# CUMBERLAND HIGH SCHOOL

# GLAZING SHOP DRAWINGS

REV	DESCRIPTION	DATE	
0	1ST SUBMITTAL	06.09.2025	RCF
1	2ND SUBMITTAL	08.13.2025	KMR
2	ENGINEERING NOTES	12.16.2025	KMR

PROJECT NUMBER:  
**25-132E**

**CW ELEVATION CW1**  
DRAWING SCALE  
24x36: 1/2" = 1'-0"  
11x17: 1/4" = 1'-0"

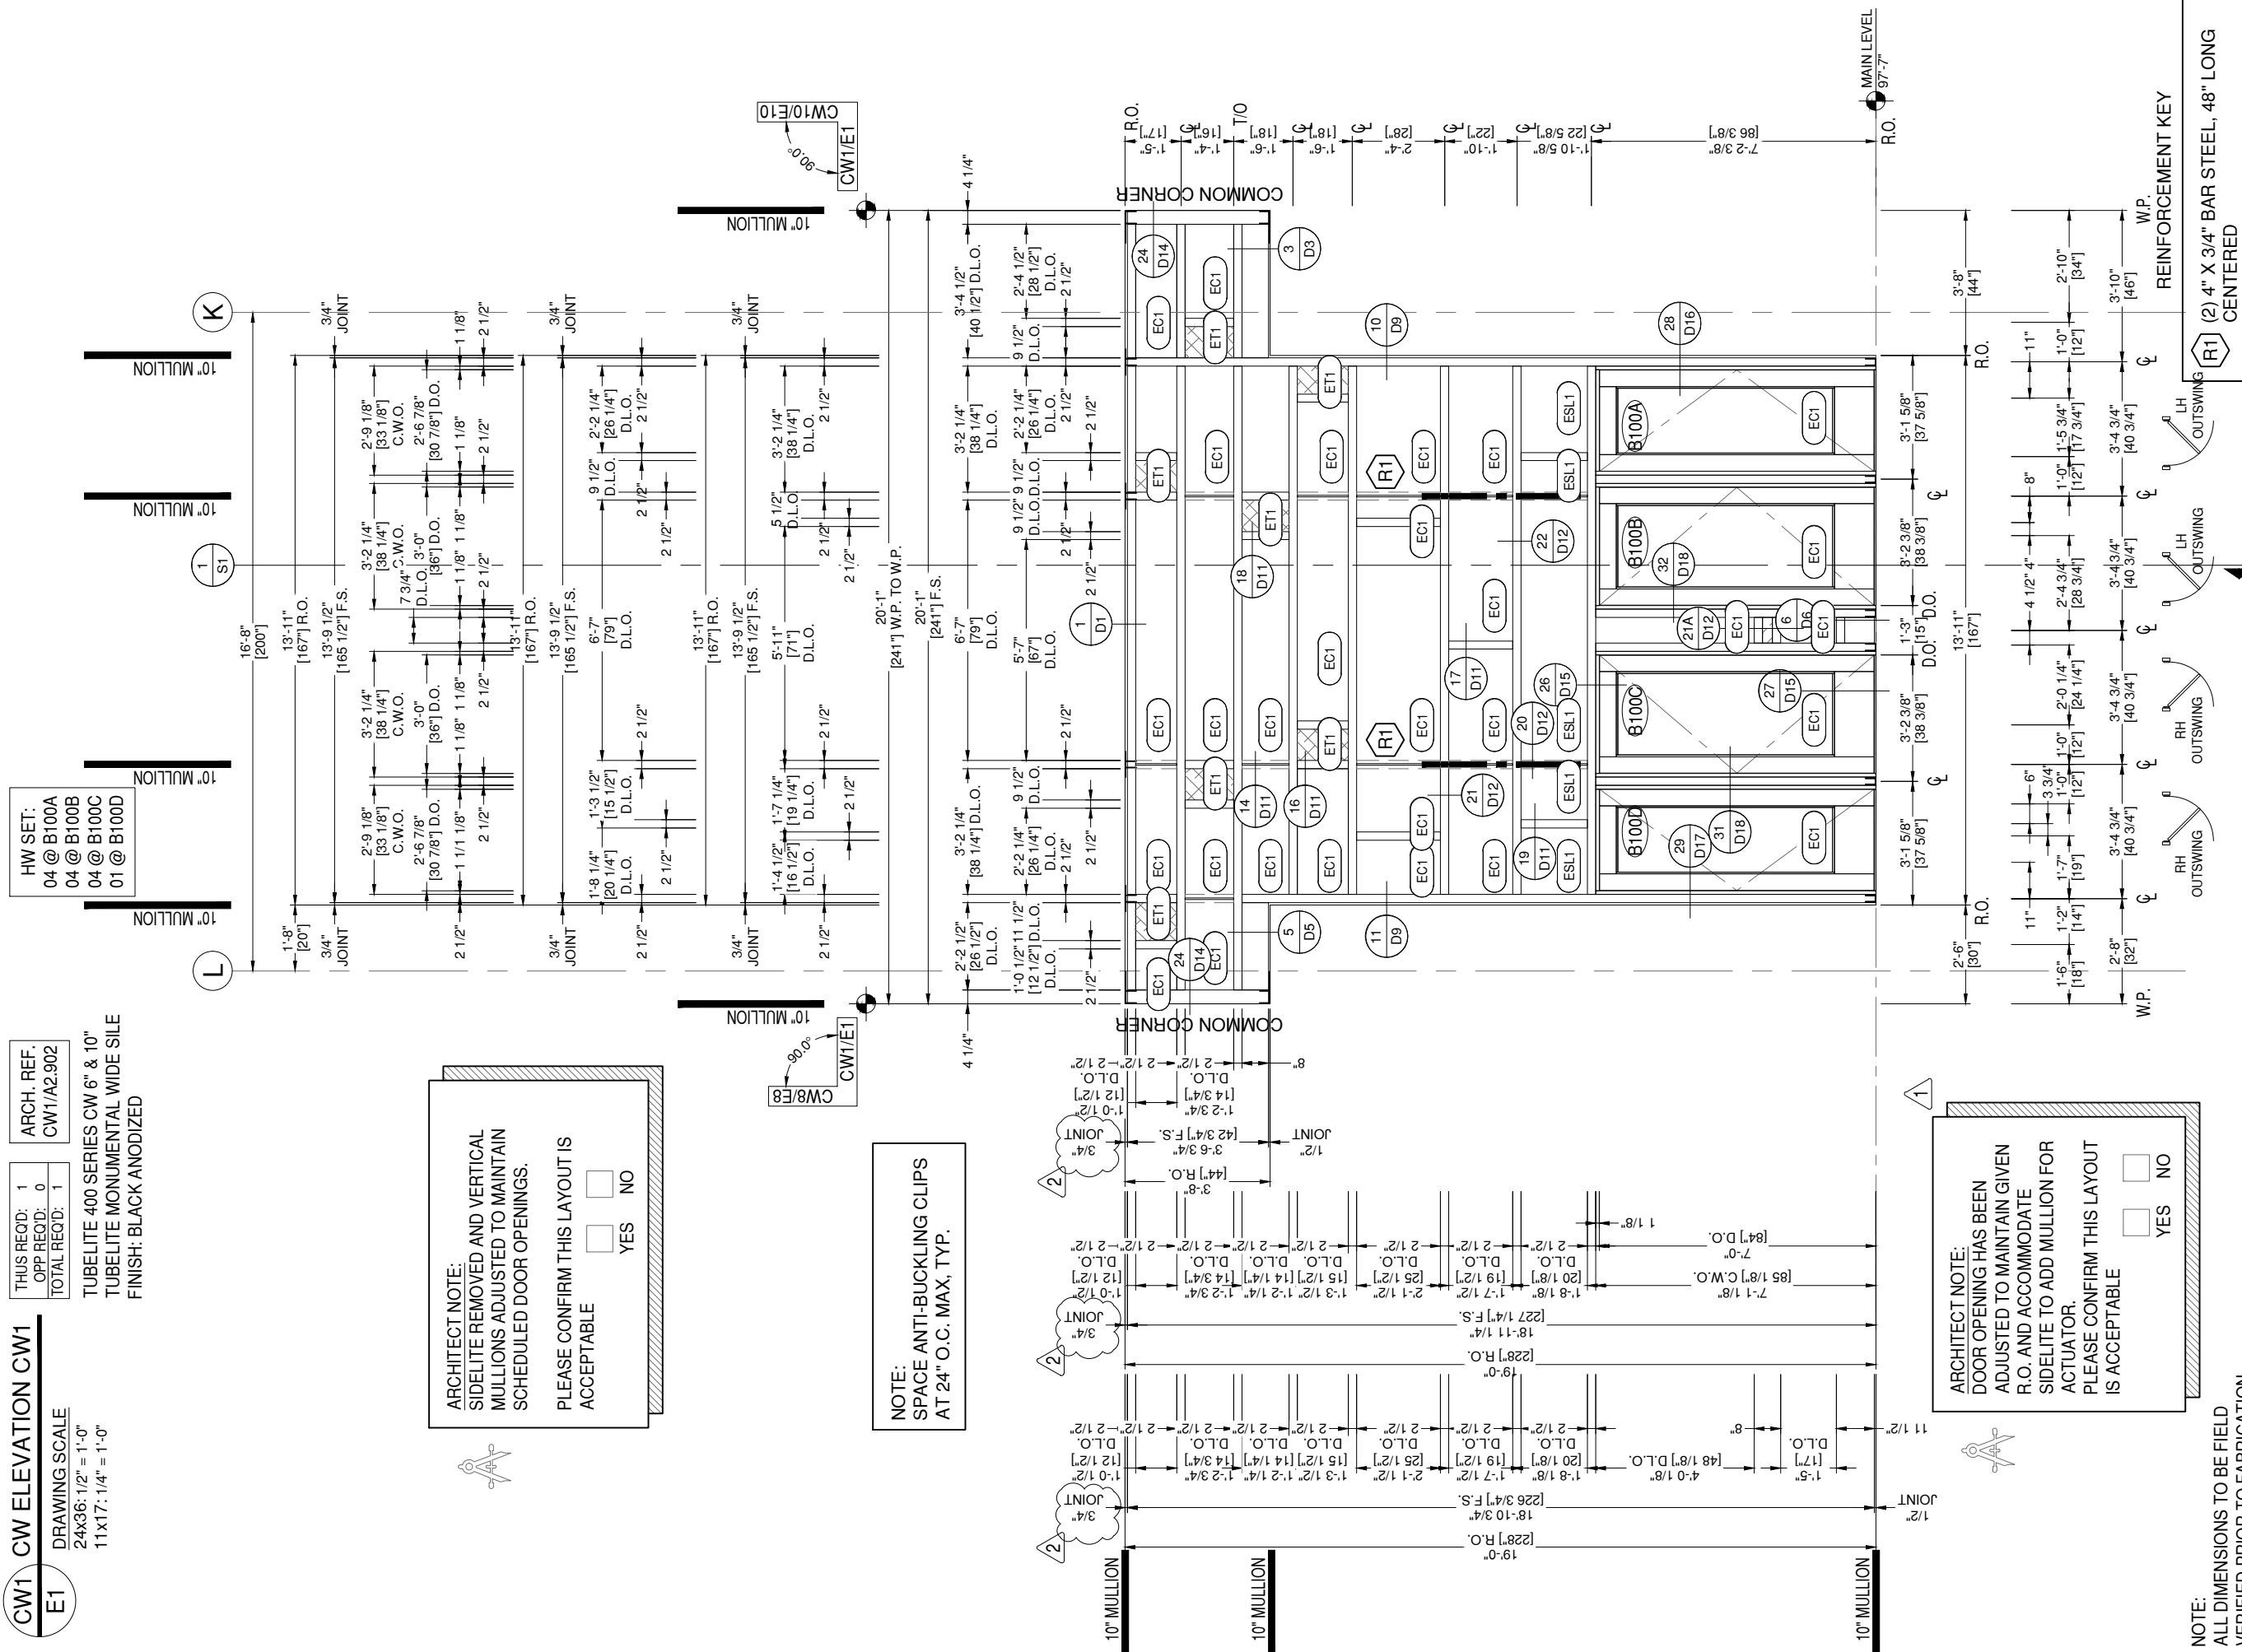
**ARCHITECT NOTE:**  
SIDELITE REMOVED AND VERTICAL  
MULLIONS ADJUSTED TO MAINTAIN  
SCHEDULED DOOR OPENINGS.

PLEASE CONFIRM THIS LAYOUT IS  
ACCEPTABLE  YES  NO

**ARCHITECT NOTE:**  
DOOR OPENING HAS BEEN  
ADJUSTED TO MAINTAIN GIVEN  
R.O. AND ACCOMMODATE  
SIDELITE TO ADD MULLION FOR  
ACTUATOR.  
PLEASE CONFIRM THIS LAYOUT  
IS ACCEPTABLE  YES  NO

2 C4 HEAD DETAIL 400TU  
D2 A5.604  
DRAWING SCALE  
24x36: 3/4:1  
11x17: 3/8:1

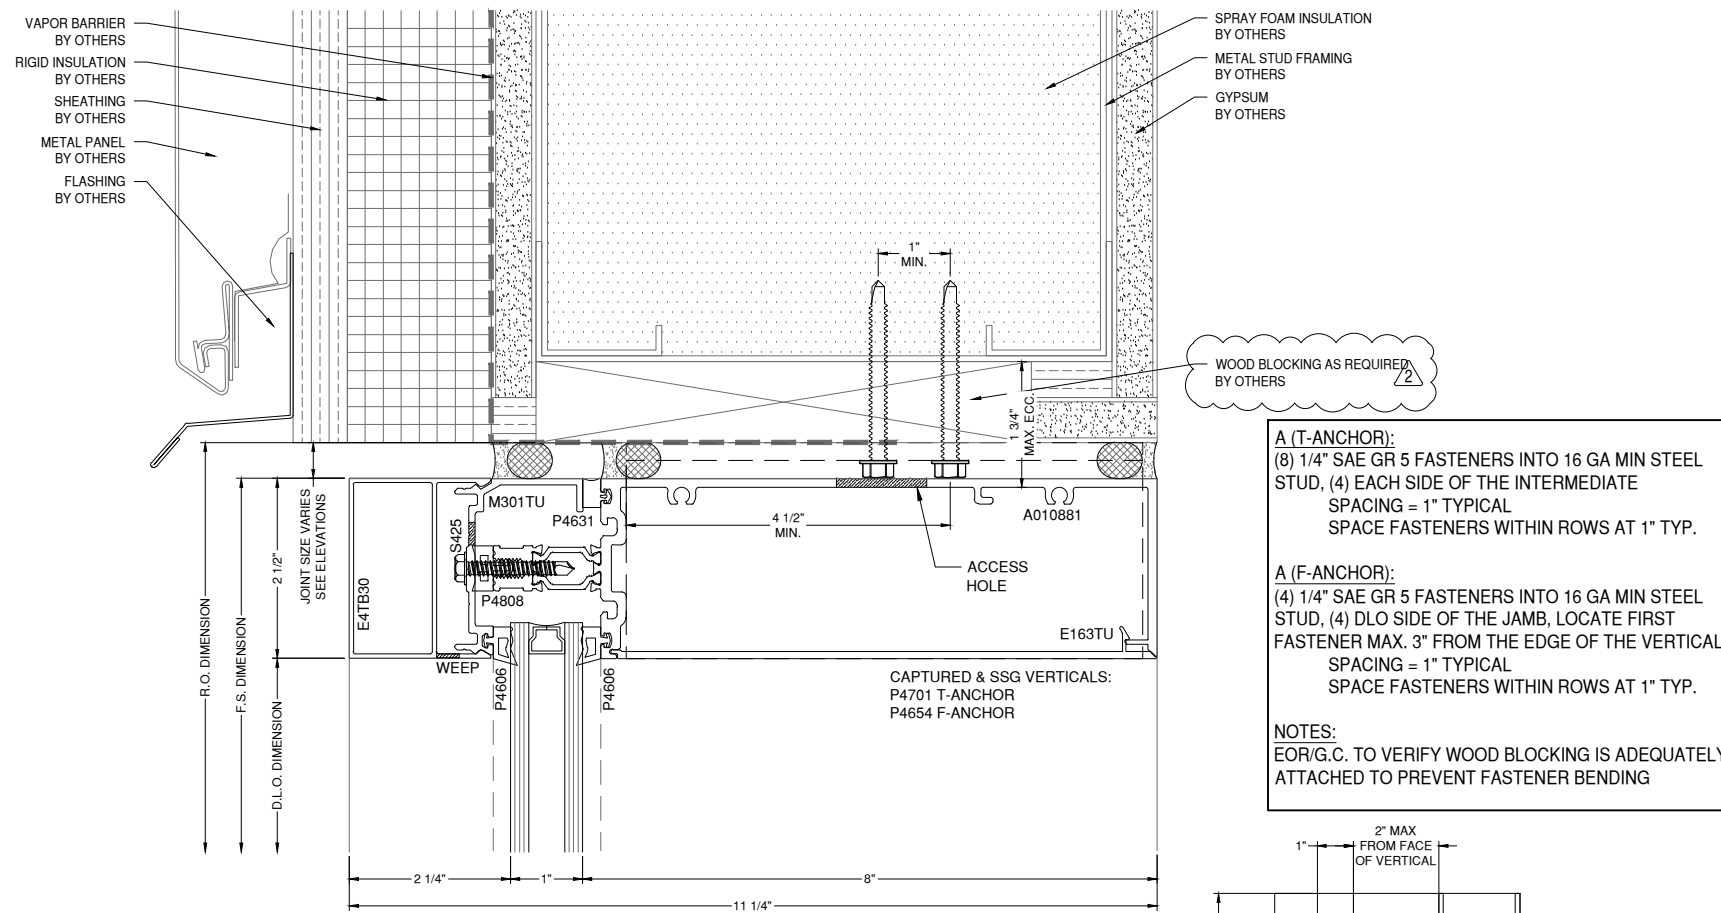
**NOTES:**  
EOR/G.C. TO VERIFY WOOD BLOCKING IS ADEQUATELY ATTACHED TO PREVENT FASTENER BENDING

SHEET:  
**D11**

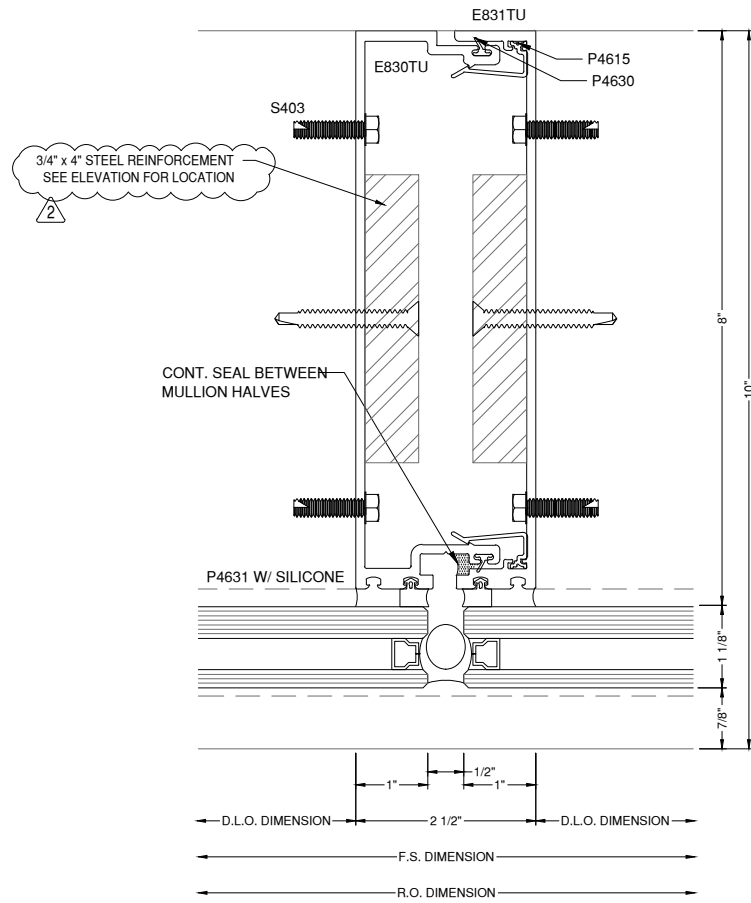
SYSTEM NOTE:  
PLEASE VERIFY GASKETS AT  
FRAME. 1-1/8" GLAZING SHOWN  
WITH 1" GASKETS.

23  
D13  
CORNER DETAIL  
DRAWING SCALE  
24x36: 3/4:1  
11x17: 3/8:1  
400TU

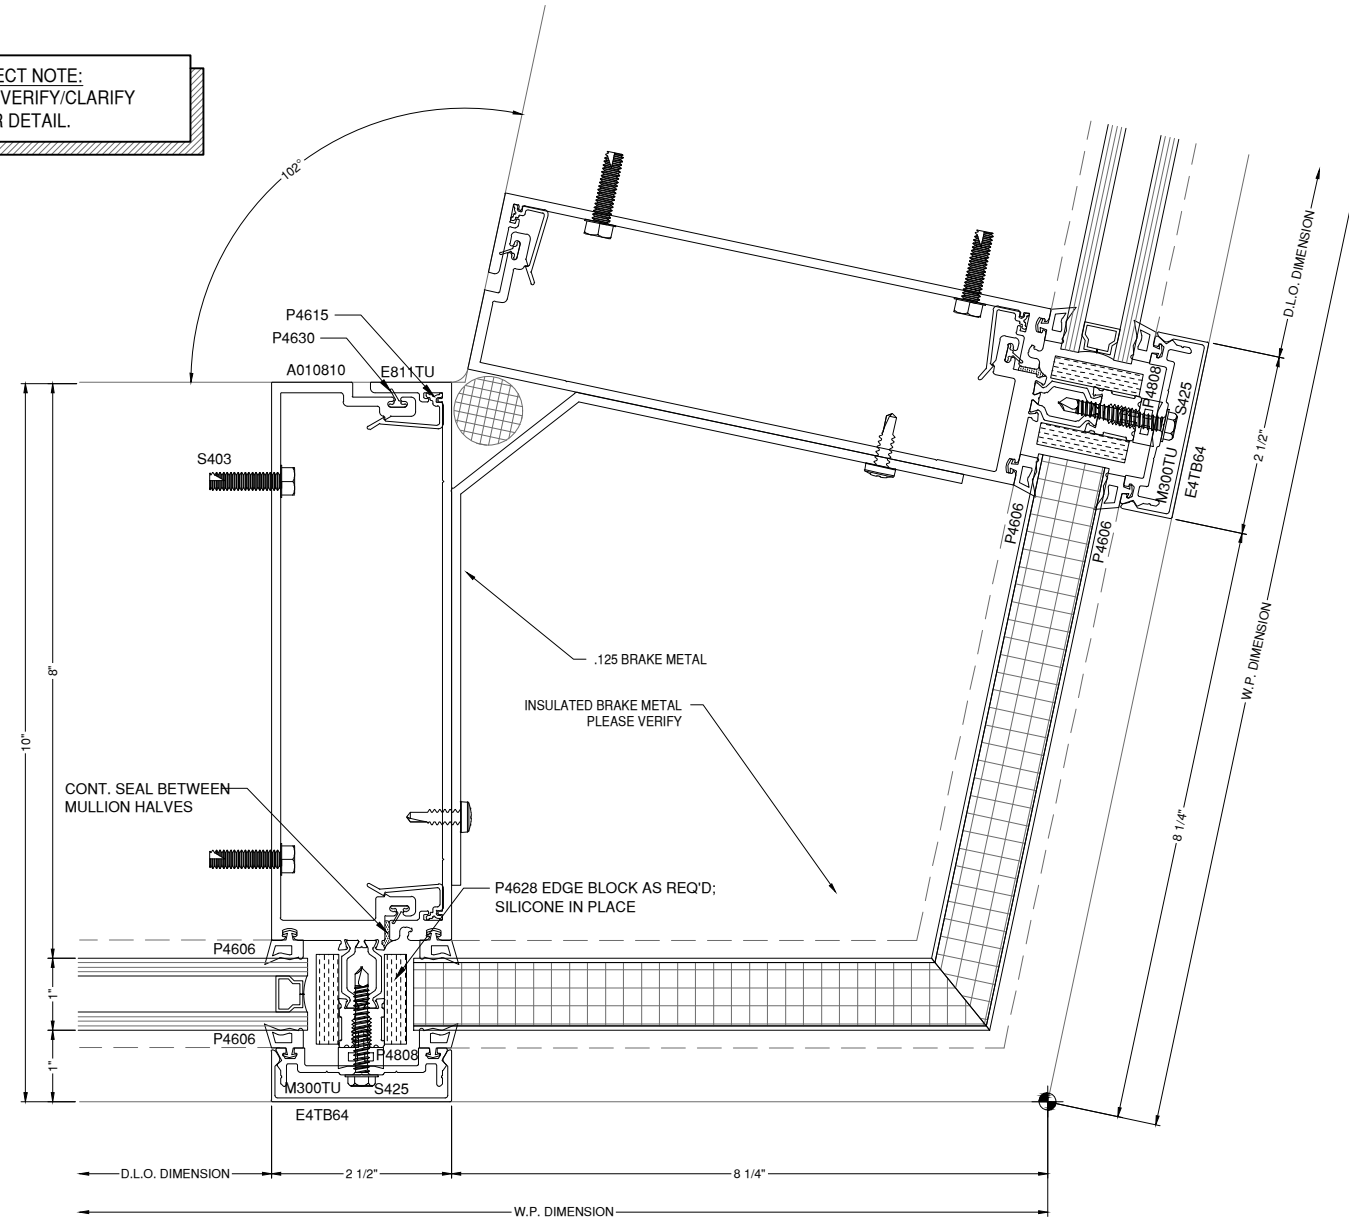
ARCHITECT NOTE:  
PLEASE VERIFY/CLARIFY  
CORNER DETAIL.
